2.2: PROJECT NUMBER.
3018292

2.3: MEETING TYPE AND MEETING DATE.
DESIGN REVIEW BOARD RECOMMENDATION MEETING
12.19.16

DESIGN REVIEW: RECOMMENDATION PROPOSAL
2417 NW 57TH ST - SEATTLE, WA 98107
DPD# 3018292 | 12.19.16
PARCEL#: 2767700040

SECOND EARLY DESIGN GUIDANCE

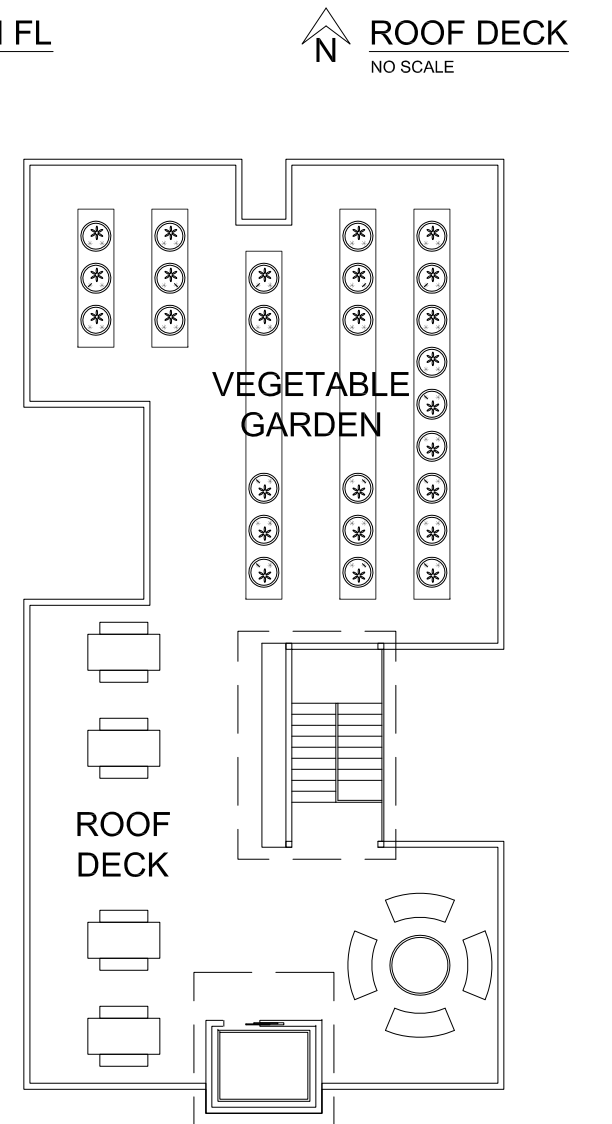
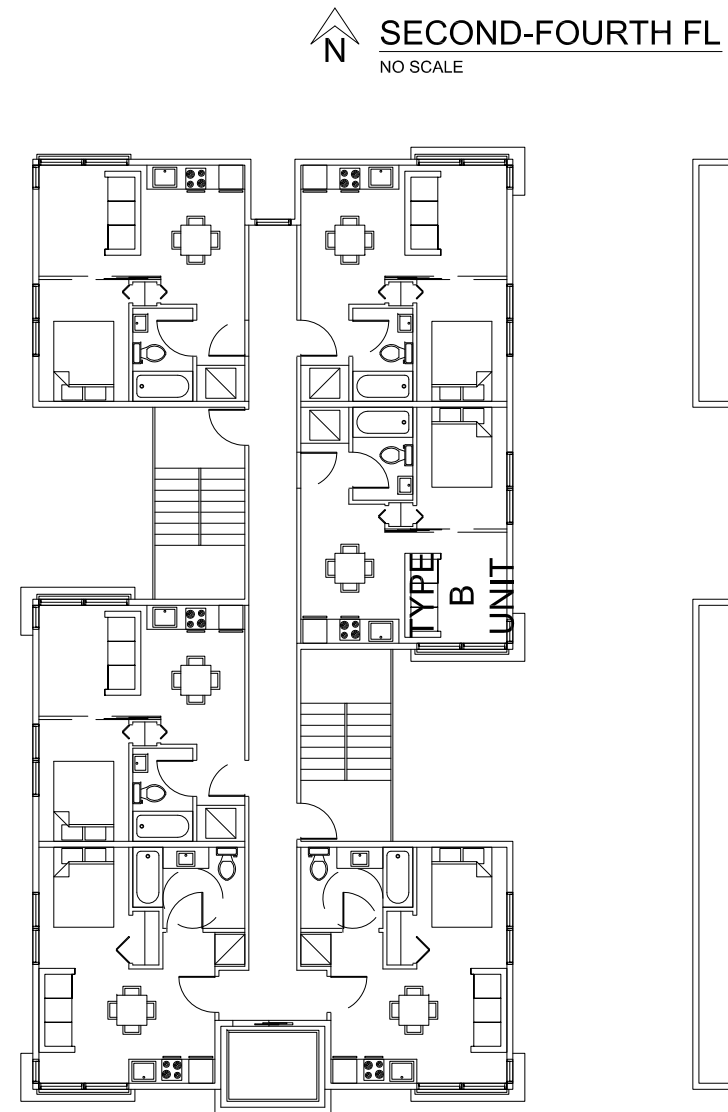
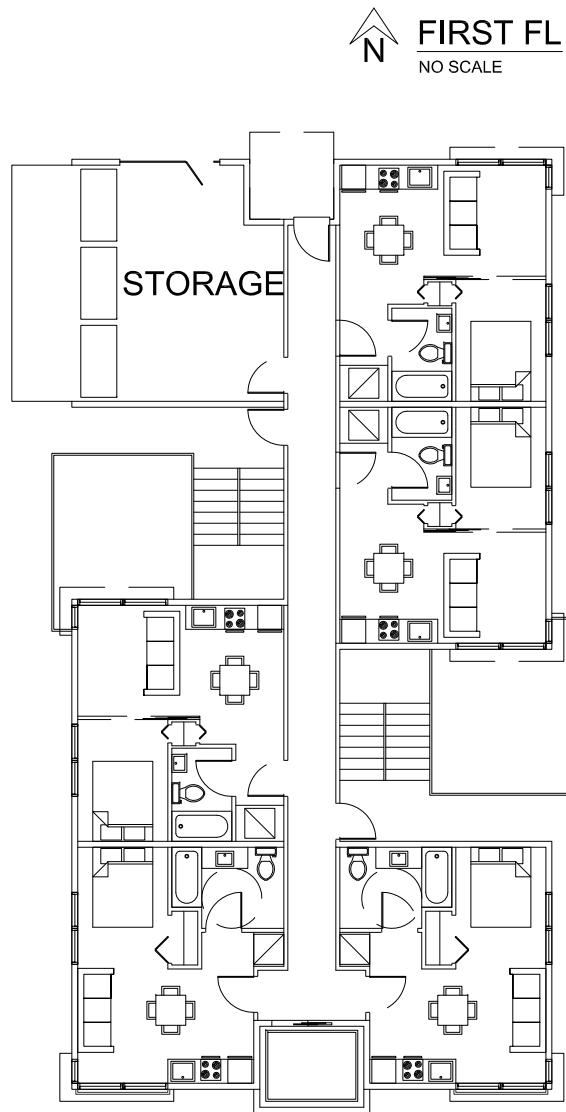
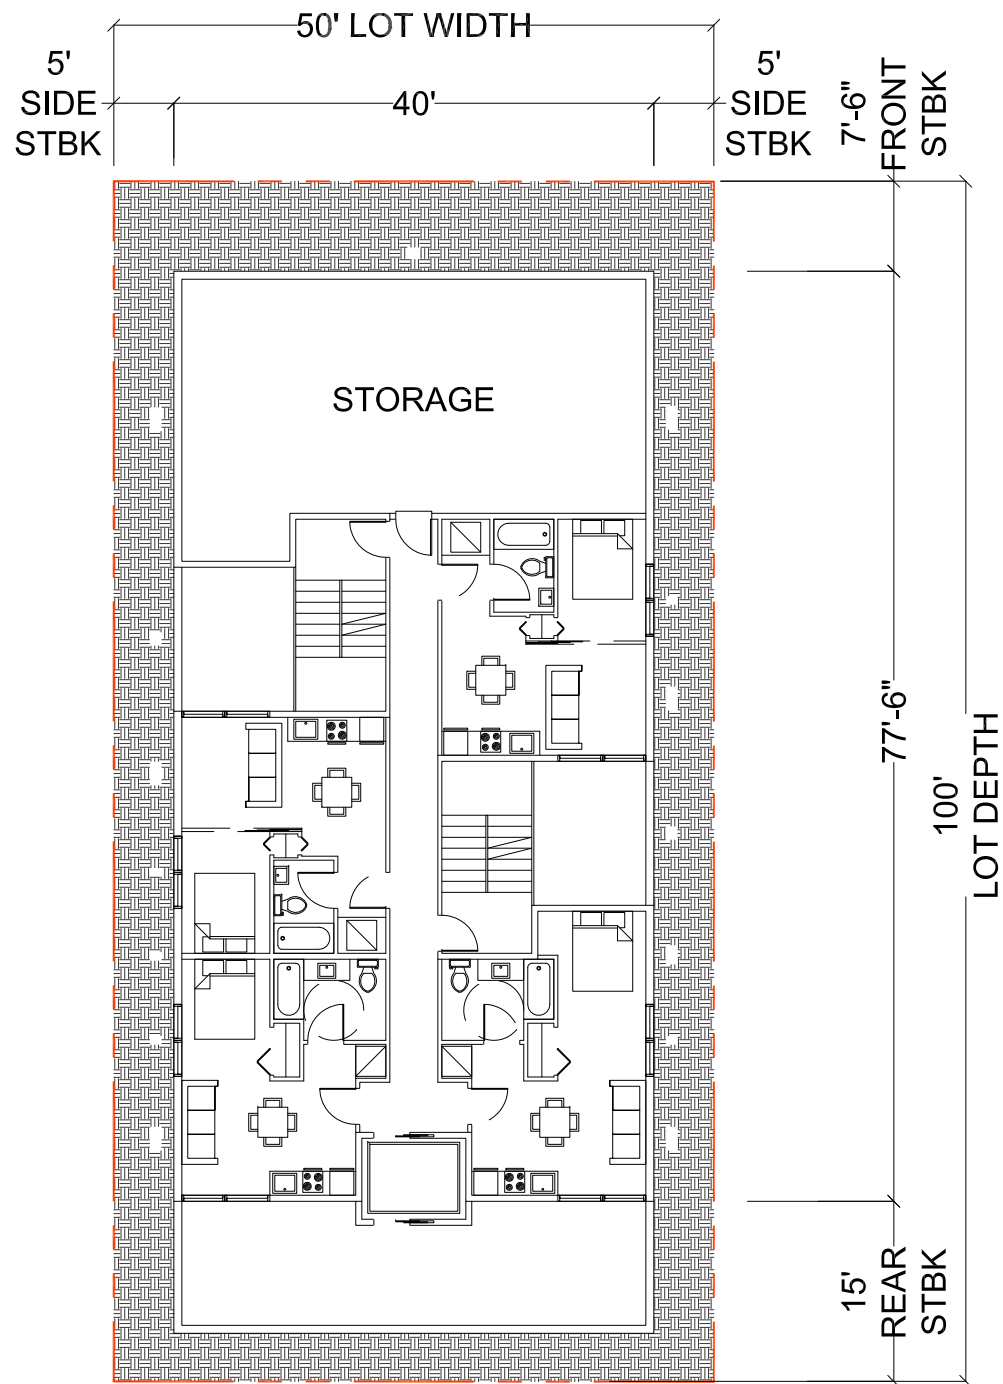
HEIGHT, BULK AND SCALE
THE BOARD WAS IN FAVOR OF THE BUILDING MASSING AND ARTICULATION AS VIEWED FROM THE STREET ESPECIALLY AND FAVORED THE BUILDING FORMS AS DEMONSTRATED. THE BOARD AGREED WITH THE APPLICANT THAT THE SOLID PARAPET MAY REMAIN AS SHOWN AND SERVE ITS SCREENING PURPOSE.
SOLID PARAPET MAINTAINED

STREET LEVEL INTERACTION
THE BOARD AGREED WITH THE CLARIFICATION OF THE USES AND CONFIGURATION OF SPACE AT THE GROUND FLOOR BICYCLE GARAGE. THE BOARD AGREED THAT THE PUBLIC ENTRY AND PRIVATE GROUND LEVEL SPACE WAS BETTER ARTICULATED AND THAT THE APPLICANT SHOULD MOVE FORWARD WITH THE CONCEPTS SHOWN.
CONCEPT CONTINUED AND DEVELOPED WITH A CLEARER SEPARATION FROM WASTE AND BIKE STORAGE.

OPEN SPACE ACCESS
THE BOARD LIKED THE OPEN SPACE FOR RESIDENTS AT THE BASEMENT LEVELS AND AMENITY SPACE OPTIONS FOR RESIDENTS AS SHOWN AT THE MEETING.
CONCEPT CONTINUED AND DEVELOPED WITH THE ADDITION OF A LANDSCAPE ARCHITECT TO DESIGN THE HARDSCAPE AND PLANTINGS
